## OFFICE OF CLIMATE, LICENSING & RESOURCE USE

### INSPECTOR'S REPORT ON A CERTIFICATE OF AUTHORISATION APPLICATION

TO:	DIRECTORS	
FROM:	Caroline Connell	- Environmental Licensing Programme
DATE:	8 <sup>th</sup> June 2011	
RE:	<p>Application for a Certificate of Authorisation from:  <b>Cork County Council</b>, Inniscarra, Co. Cork,  for a historic unlicensed waste disposal landfill facility at:  Newmarket, Co. Cork.  Certificate of Authorisation Register Number <b>H0001-01</b></p>

**Figure 2: Site Layout.**

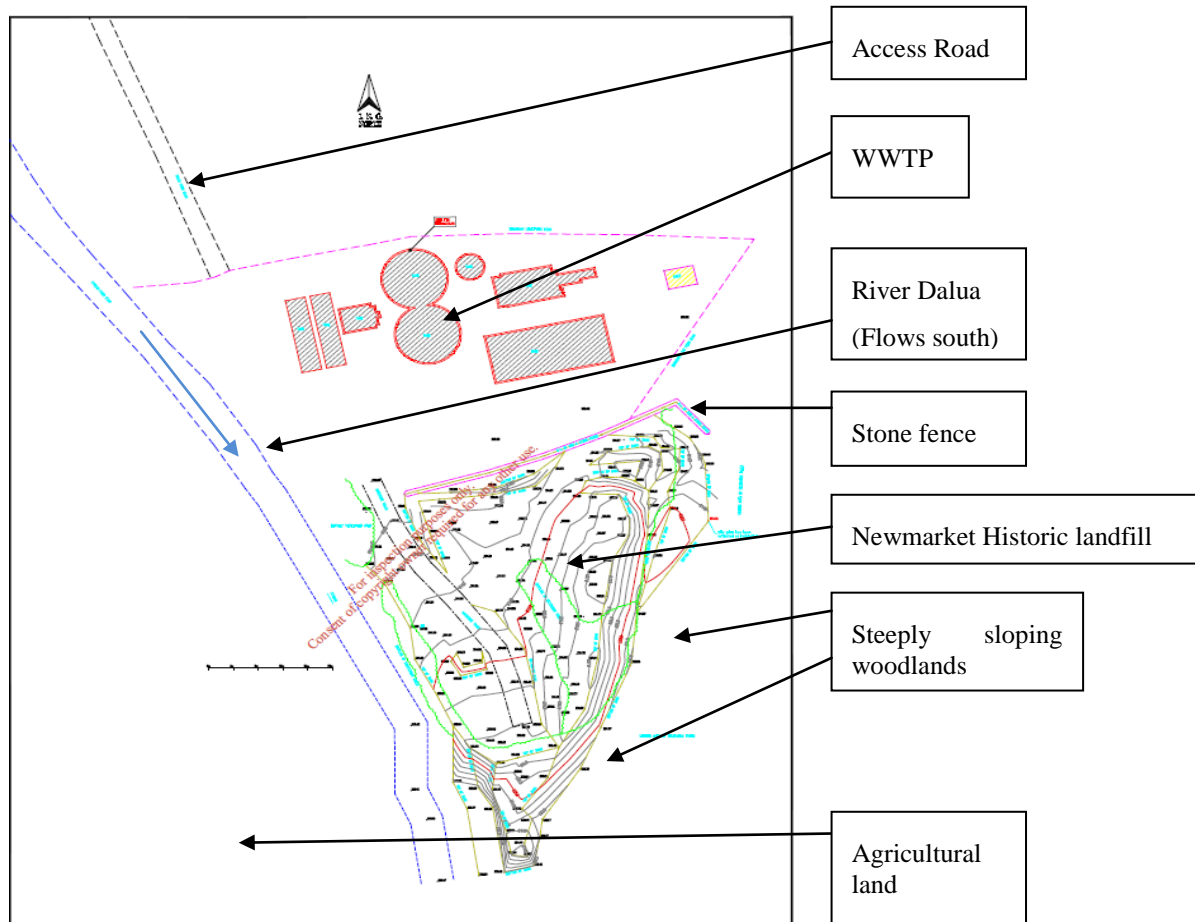
- The southern extent of the landfill had to be defined visually as this area could not be accessed.
- The lateral extent of the waste shown in Figure 2 above below covers an area of approximately 2,300m<sup>2</sup>.
- It has been estimated that approximately 4,000m<sup>3</sup> of waste is deposited at the site.

**Figure 4: Refined Conceptual Site Model (Tier 3).**

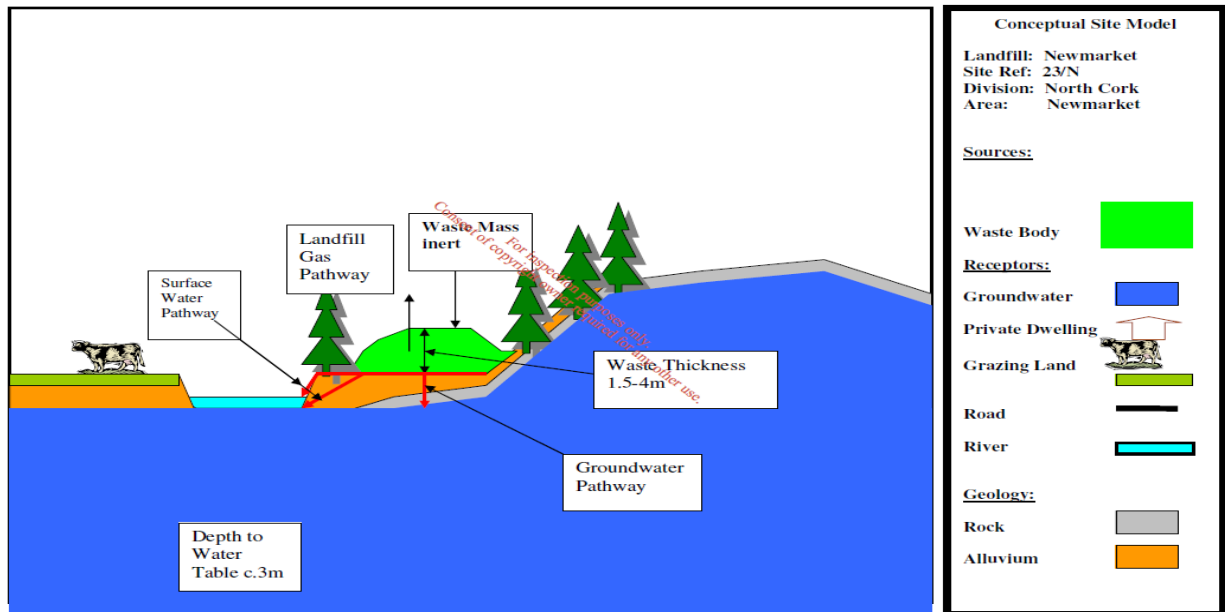
Rain falling on the waste body will infiltrate the waste and discharge along the base into the surrounding surface water streams or migrate vertically toward the subsoils (see Figure 4 on page 7). The natural subsoils beneath the waste have been reported to be of low permeability and appear to retard the movement of infiltrating rainfall. It is likely that most rainfall reaching the base of the waste will ultimately discharge laterally along the base of the waste into the surrounding surface water drainage system with a small amount reaching the water table and ultimately entering the adjacent Dalua River as shallow baseflow.

Borehole installations at the site confirmed the aquifer vulnerability rating with depth to bedrock levels recorded at one metre below ground level (mbgl) in BH-4, 1.1mbgl in BH-5 and 1.8mbgl in BH-6. The depth to the water table is approximately 3m as demonstrated in Figure 4 above. Groundwater samples were taken from BH-4, BH-5 and BH-6 on the 24 June 2008. Samples were analysed for a range of organic and inorganic parameters. All samples analysed were below their respective IGV Guideline limits except in the following cases:

The Tier 3 Assessment involved a review of the Tier 1 conceptual site model (CSM – Figure 4 on page 7) after the Tier 2 Assessment was complete. In line with the COP, Cork County Council determined that a Quantitative Risk Assessment was not required to be undertaken due to the low risk rating determined by the Tier 2 Assessment.

**Figure 5: Special Area of Conservation**

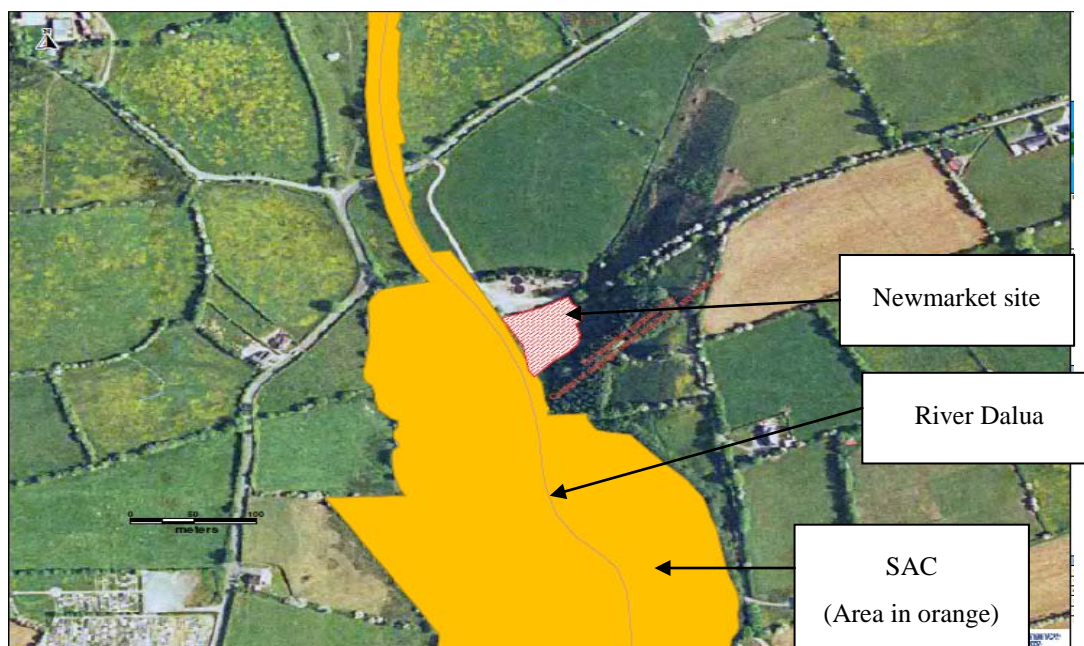
As shown in Figure 5 below the landfill site is adjacent to the Blackwater River Special Area of Conservation (SAC) (Site Code 002170).

Cork County Council have concluded that the landfill is not impacting on the groundwater or the surface water and that it is therefore not impacting on the SAC adjacent to the site.

When managed in accordance with the Certificate of Authorisation, there should be no environmental emissions from the facility that would give rise to adverse effects on this designated site.
